## Lloyd's Register of Shipping.

S.S. "Bolbec".

Memorandum of alterations reported since ship was surveyed for assignment of Load Lines in Port Talbot. 11<sup>th</sup> August 1932.

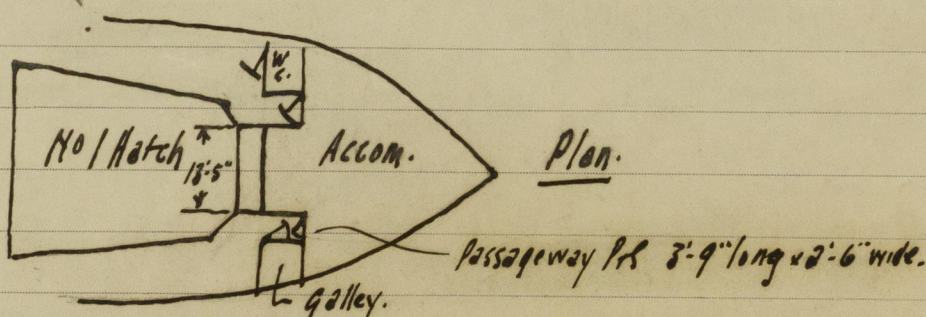
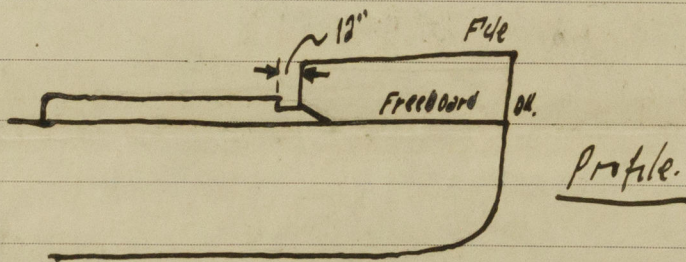
No 1 Hatch. Increased in length 12" forward and covering plate sloped as per sketch. Dimensions of hatchway 26'-2" x (23'-7" x 16'-2" x 17'-5" breadth.) The forward hatch beam is now fitted with double 6" x 3 1/2" x 50" B.A.s as bottom bars.

4" x 3" x 36"  
15 1/2" x 36"  
6" x 3 1/2" x 50" B.A.s ✓

3" wood hatch covers, cleats, bolting bars etc fitted as per rule requirements for forward bay of hatchway. Covering plates 45".

F'dle Front.

Steel plating suitably stiffened by 3" x 3" x 36" angles 2'-6" apart. Hinged wood door fitted opening from both sides. Size 5'-0" x 24" x 2" thick - 19" ribs.
